Attachment 9.1 Facilities Audit

Town of Shelburne

As part of the Town of Shelburne Self-Evaluation, the following facilities were evaluated:

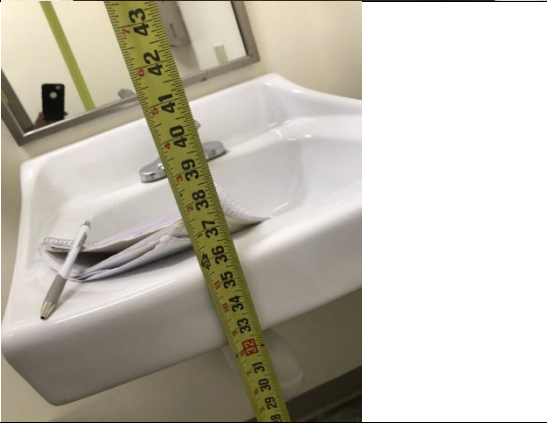
| 4 | Storefront Awnings Extend Below 80"; Leading Edges Not More Than 80" Above the Finish Surface Cannot Protrude More Than 4" Horizontally Into the Circulation Path | 307.2 |  | Assume that awnings will not be removed. To ensure clear width for passage along a sidewalk beyond the leading edge of the awnings install tree well grates and limit other objects such as sandwich sign boards and newspaper boxes. |

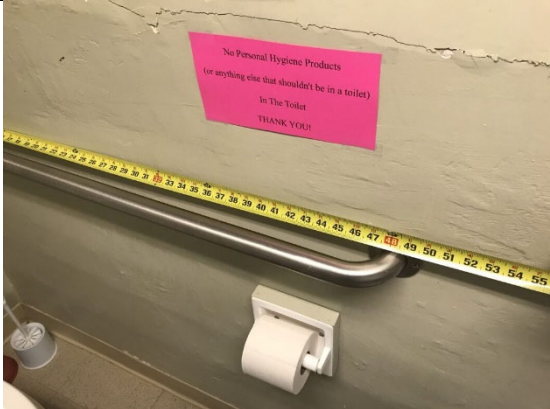
No Accessible Route From Front of Building to Rear Accessible Rear Entrance

402

Provide accessible route from front of the library and street right of way, down Bridge Street and along west side of library lawn to rear accessible entrance. The accessible route also would provide access to picnic tables at the rear of the library. An accessible route would negate the current system where travel is through the bank drive-through driveway since there is no sidewalk. The bank driveway includes speedbumps and deteriorated asphalt. It's unclear if the bank driveway is bank or Town property.

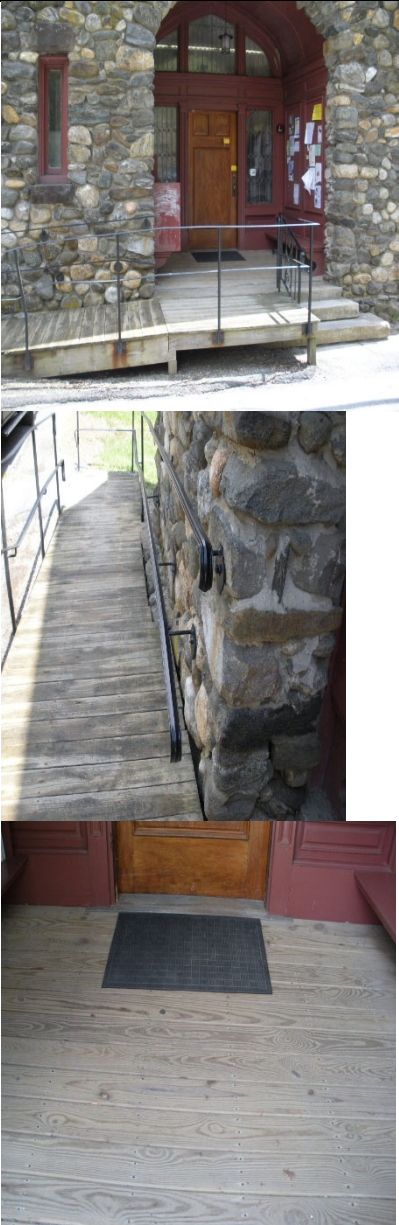
| 3 | <p>Rear Accessible Entrance- Need Signage for Rear Door; Walkway in Poor Condition; No Level Landing (2.4%); Flower Pot Obstructs Landing; Entrance Door at Lower Level Inoperable at Time of Audit</p> | <p>216.6; 405.7.1</p> |  | <p>Install rear entrance sign with International Symbol of Accessibility. Repair rear sidewalk to ensure smooth route of travel from parking area to rear accessible door. Move flower pot which obstructs landing-walk. Replace landing at rear door to ensure</p> |
